PIC24FJ256GA110 Family Silicon Errata and Data Sheet Clarification

The PIC24FJ256GA110 family devices that you have received conform functionally to the current Device Data Sheet (DS39905E), except for the anomalies described in this document.

The following typographic corrections and clarifications are to be noted for the latest version of the device data sheet (DS39905E):

FIGURE 2-3 FREQUENCY vs. ESR PERFORMANCE FOR SUGGESTED VCAP

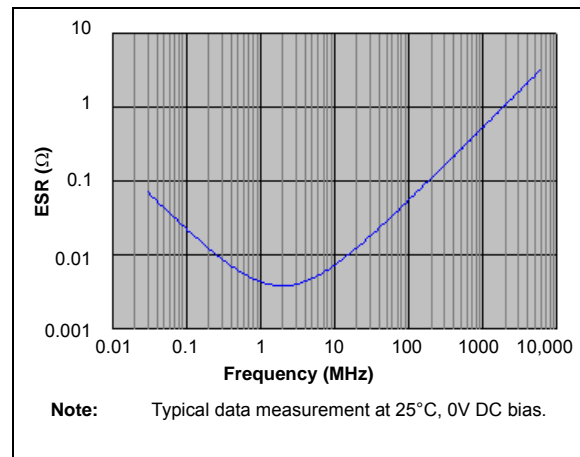
Section 2.4 Voltage Regulator Pins (ENVREG/DISVREG and VCAP/VDDCORE) has been replaced with a new and more detailed section. The entire text follows:

When the regulator is enabled, a low-ESR ($< 5\Omega$) capacitor is required on the VCAP/VDDCORE pin to stabilize the voltage regulator output voltage. The VCAP/VDDCORE pin must not be connected to VDD and must use a capacitor of $10\ \mu\text{F}$ connected to ground. The type can be ceramic or tantalum. Suitable examples of capacitors are shown in [Table 2-1](#). Capacitors with equivalent specifications can be used.

Designers may use [Figure 2-3](#) to evaluate ESR equivalence of candidate devices.

The placement of this capacitor should be close to VCAP/VDDCORE. It is recommended that the trace length not exceed 0.25 inch (6 mm). Refer to **Section 28.0 “Electrical Characteristics”** for additional information.

FIGURE 2-4 DC BIAS VOLTAGE vs. CAPACITANCE CHARACTERISTICS

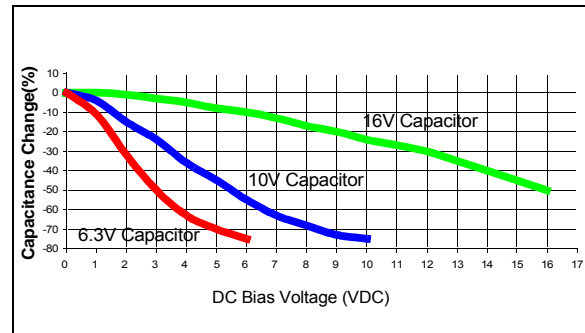
In addition to temperature tolerance, the effective capacitance of large value ceramic capacitors can vary substantially, based on the amount of DC voltage applied to the capacitor. This effect can be very significant, but is often overlooked or is not always documented.

A typical DC bias voltage vs. capacitance graph for 16V, 10V and 6.3V rated capacitors is shown in Figure 2-4.

When selecting a ceramic capacitor to be used with the internal voltage regulator, it is suggested to select a high-voltage rating, so that the operating voltage is a small percentage of the maximum rated capacitor voltage. For example, choose a ceramic capacitor rated at 16V for the 2.5V core voltage. Suggested capacitors are shown in Table 2-1.
